IMPORTANT SAFETY RECALL

Subject: Safety Recall 19PBF Model 520 RHSU Front Spring Bracket
NHTSA 19V917
EXPIRATION DATE: NONE

Federal Recall Information

Certain Model 520 vehicles with Right-Hand Standup (RHSU) configuration may have an improperly supported steering gear assist bracket

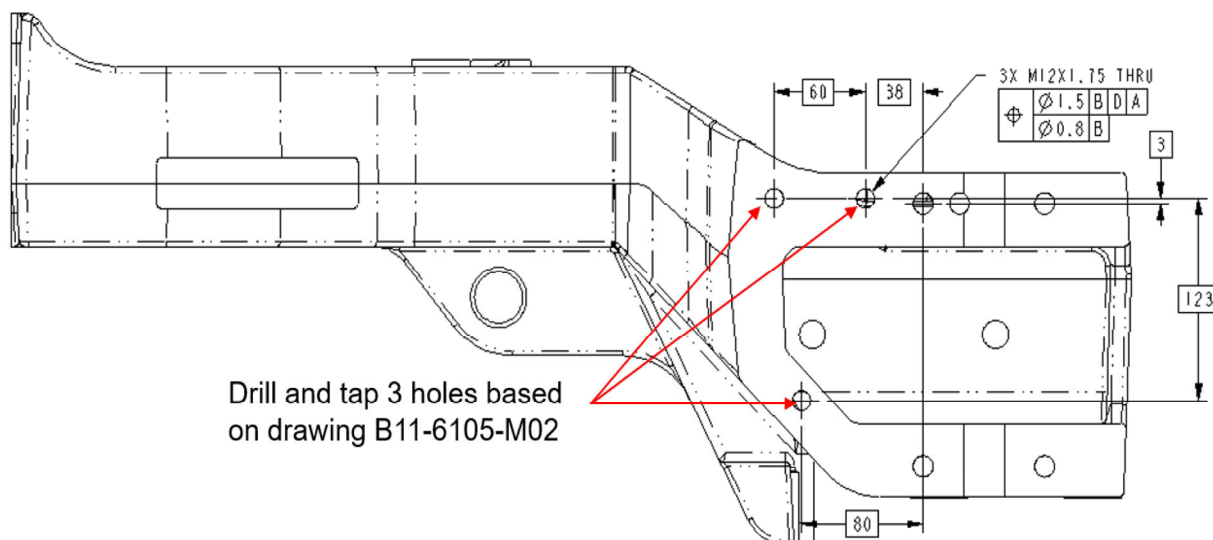
- Inspect the steering gear assist bracket to ensure it is mounted with all 5 bolts. If all 5 bolts are installed. No further action is required.
- Replace the steering gear bracket, drill and tap 3 holes per drawing B11-6105-M02R and mount the new steering gear assist bracket to the spring bracket with 5 new bolts and washers. See image below.

1. Drill – 10.3mm or 13/32 drill
2. Tap – M12 X 1.75
